## ARM Infrastructure PrimeCell AXI-AHB Bridges (BP137) **Errata Notice**

This document contains all errata known at the date of issue in releases up to and including revision r0p1 of AXIToAHB

Figure 1 Override HTRANS[0] and HBURST to uBLSCnv for write bursts

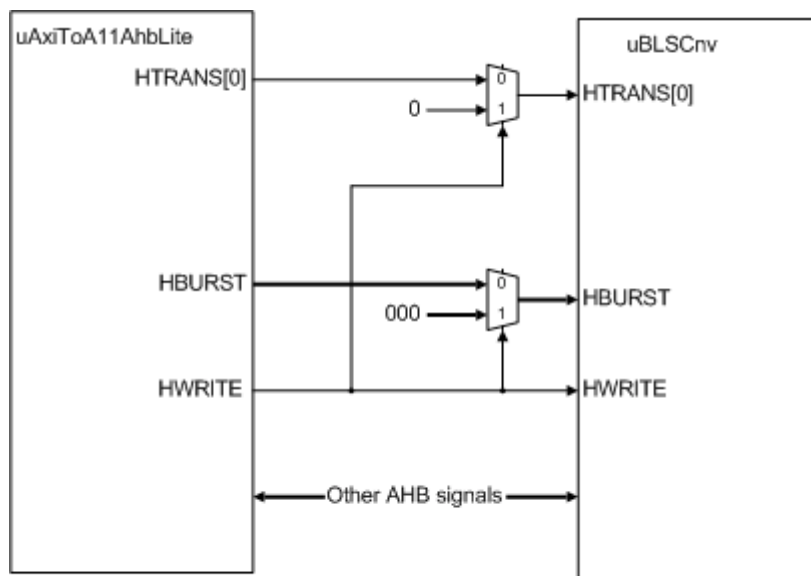
The issue arises when an AXI write transaction begins with an aligned, non-sparse write transfer but one or more subsequent write transfers in the same transaction are sparse. This causes the internal signal IHUNALIGN to transition from low to high at the output of the module AxiToA11AhbLite, as described in the Design Manual. When IHUNALIGN goes high, the byte lane strobe converter (BLScnv) converts each data transfer into series of byte transfers and the outputs HBURST, HTRANS, and HSIZE of BLScnv change. This violates the AHB protocol because the AHB transaction is mid-burst.

This breaks the AHB protocol, because HTRANS must not change from SEQ to NONSEQ, HBURST must not change from INCR8 to INCR, and HSIZE must not change from SIZE32 to SIZE8 until the first burst completes or is cancelled due to an error response.

In AxiToAhbLiteM and AxiToAhbLiteS, override the HBURST input to the module uBLSCnv to SINGLE (3'b000) or INCR (3'b001), and override the HTRANS[0] input to the module uBLSCnv to LOW(1'b0) during write bursts. This is shown in Figure 1 below:
